SEWAGE DISPOSAL SYSTEM

SUBDIVISION The Warfields LOT 16 ROAD 4808 View Way Court

RE: The Warfields, Lot #16
14808 View Way Court
Well Permit #HO-94-0239

PLOT PLAN
FOR
LOT 16
THE WARFIELDS
HOWARD COUNTY, MARYLAND

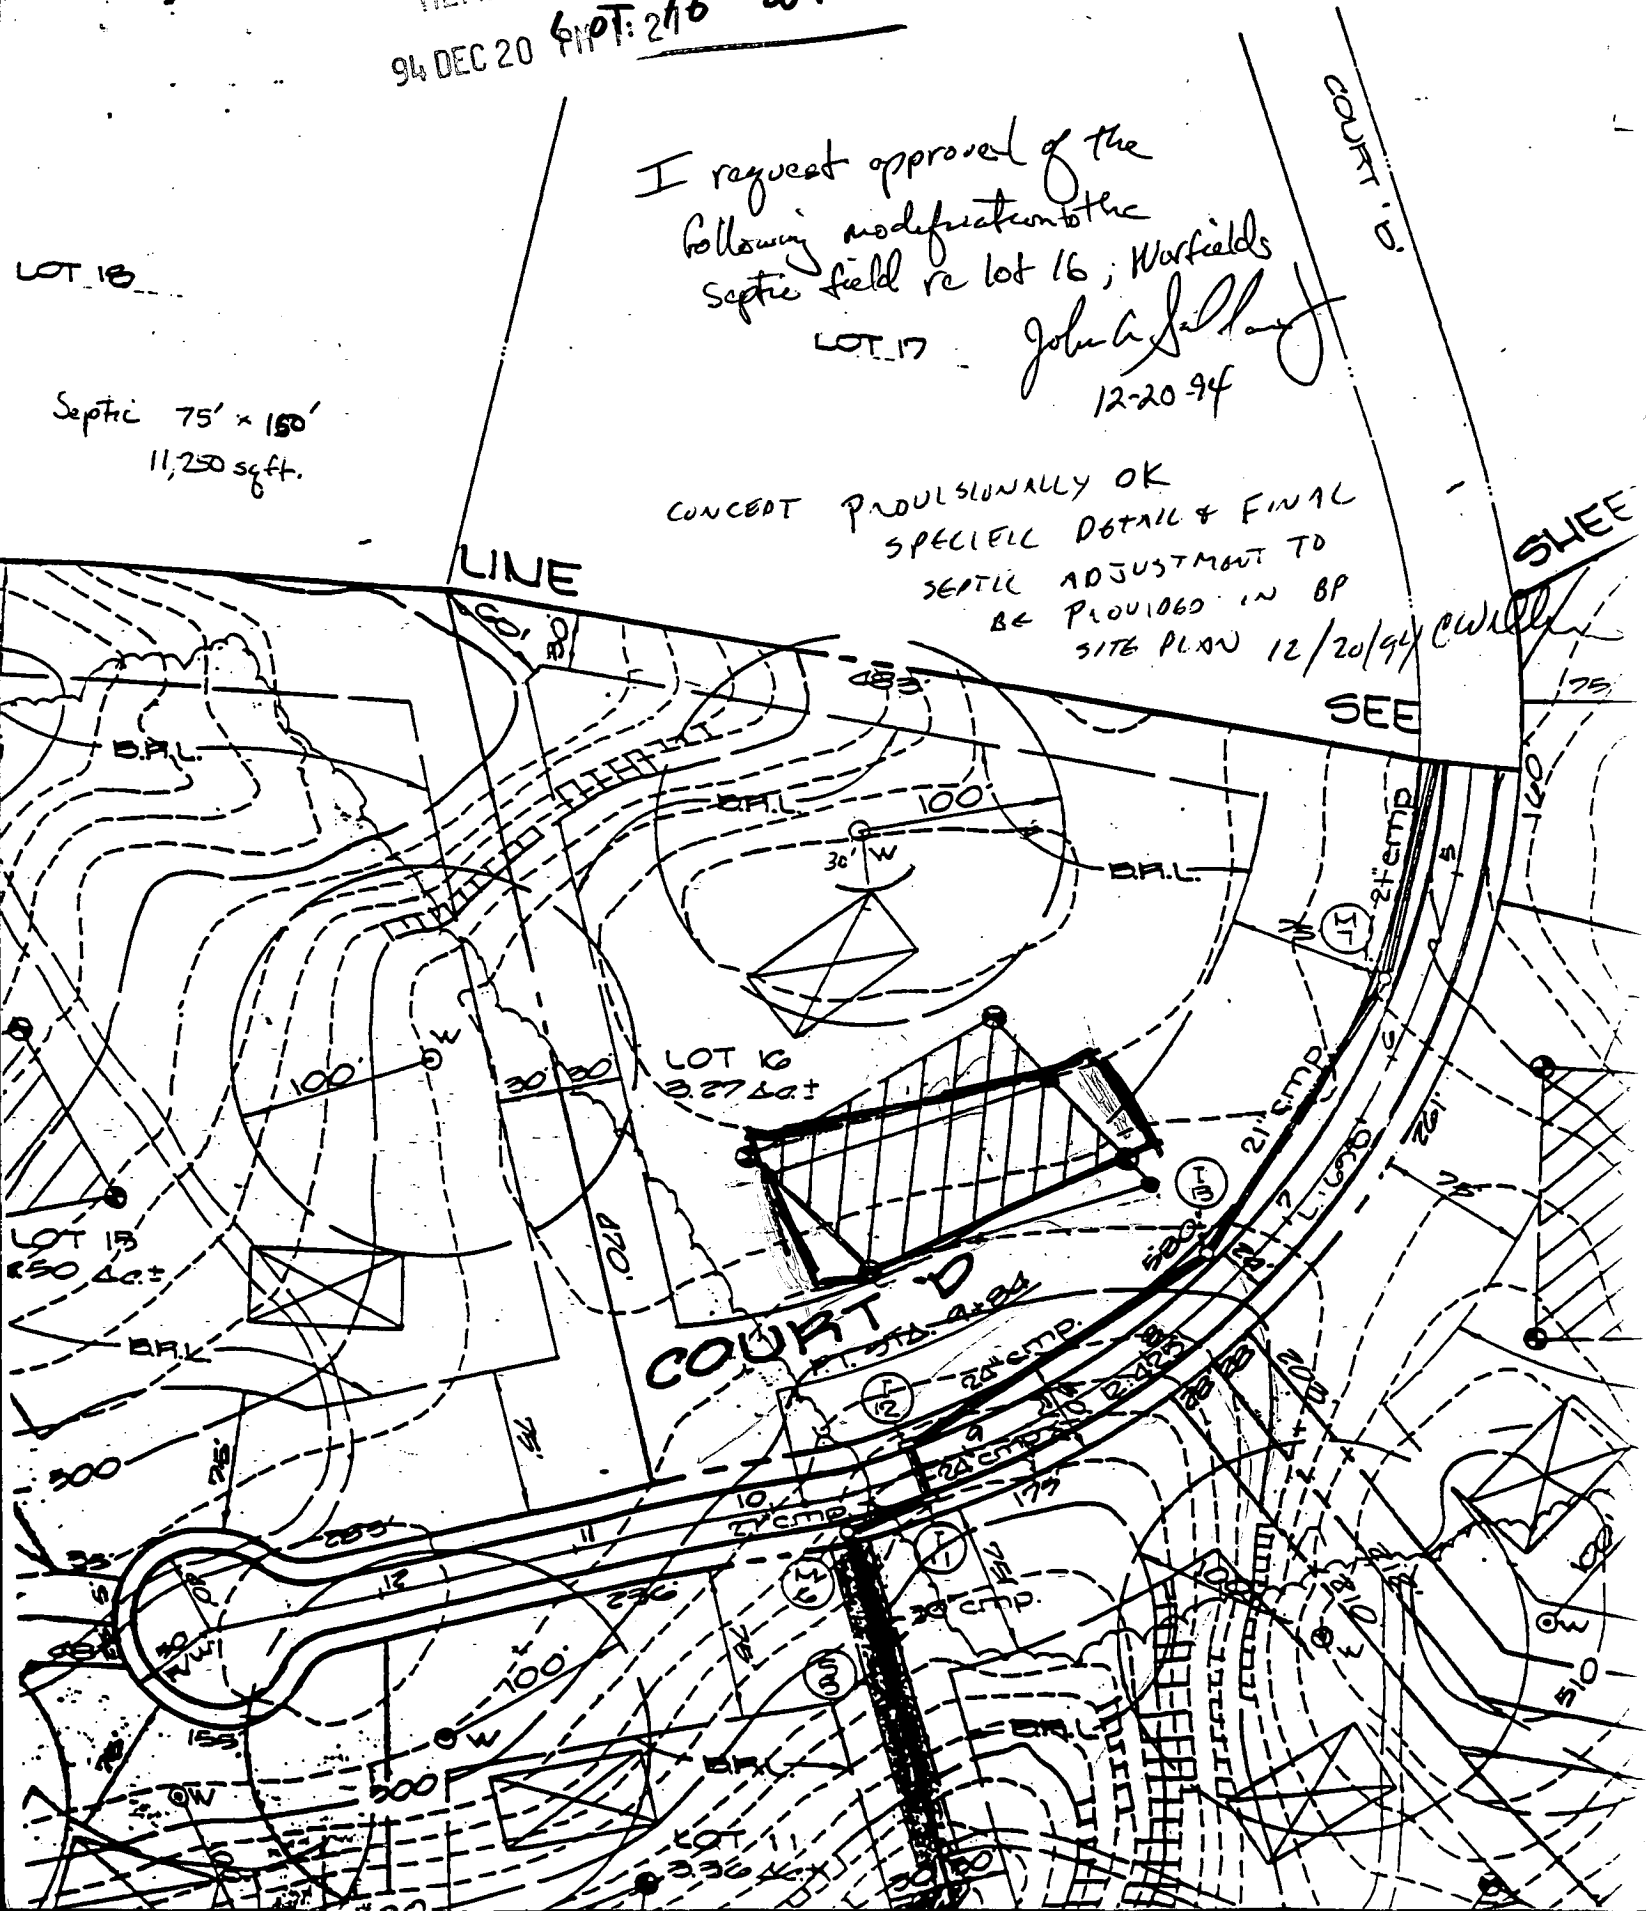
I request approval of the
following modification to the
septic field re lot 16; Warfields

Septic 75' x 150'
11,250 sq. ft.

CONCEPT PROVISIONALLY OK
SPECIFIC DETAIL & FINAL
SEPTIC ADJUSTMENT TO
BE PROVIDED IN BP
SITE PLAN 12/20/94 CW

WALK-THRU BUILDING PERMIT

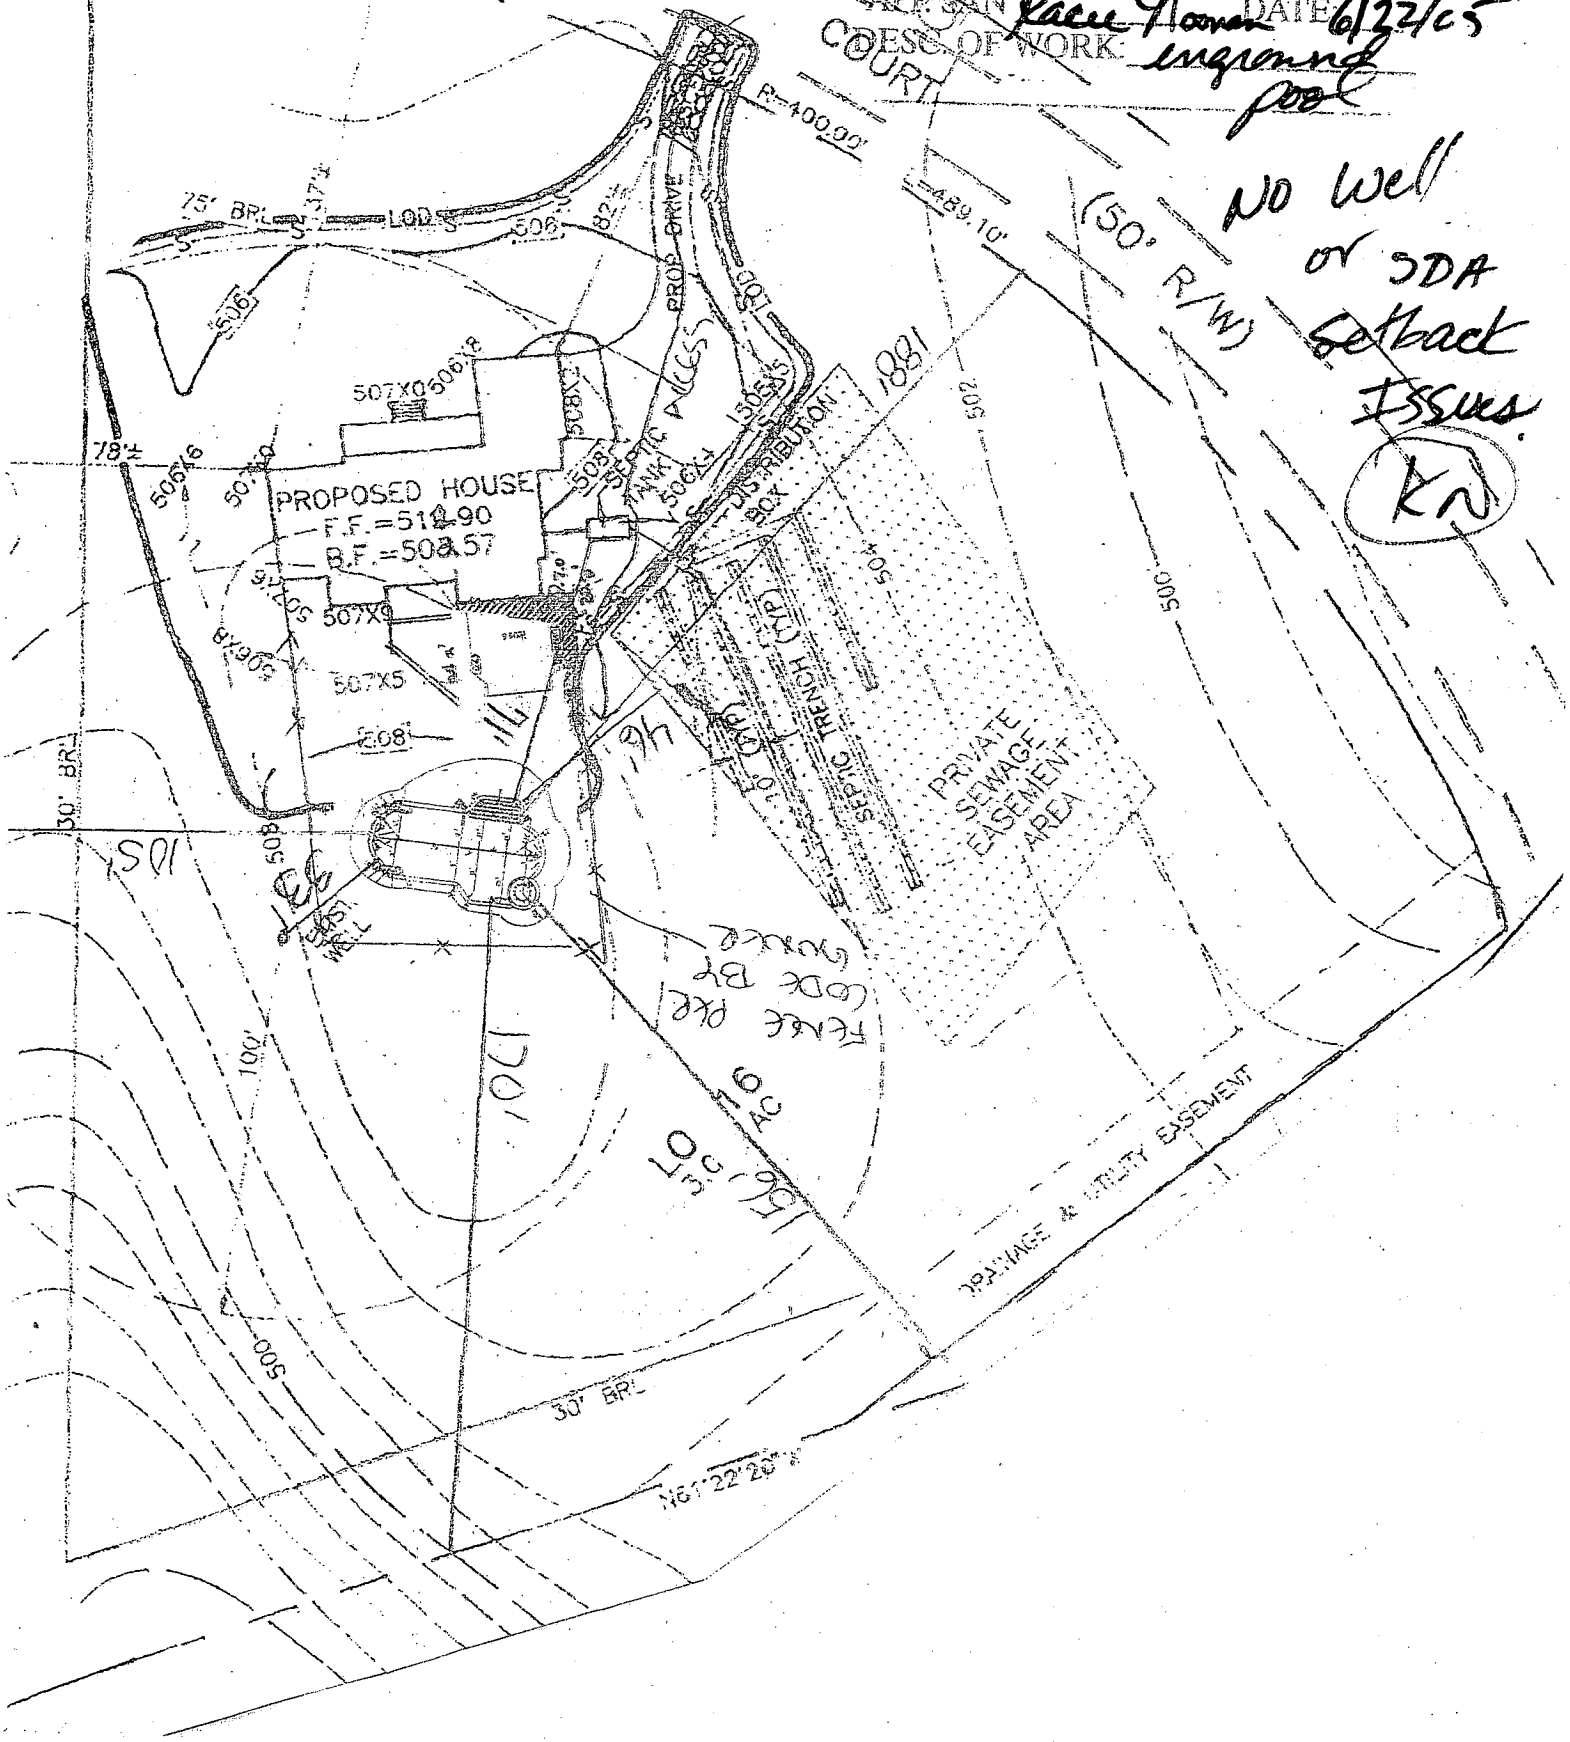
inground pool

No well
or SDA
setback
issues.
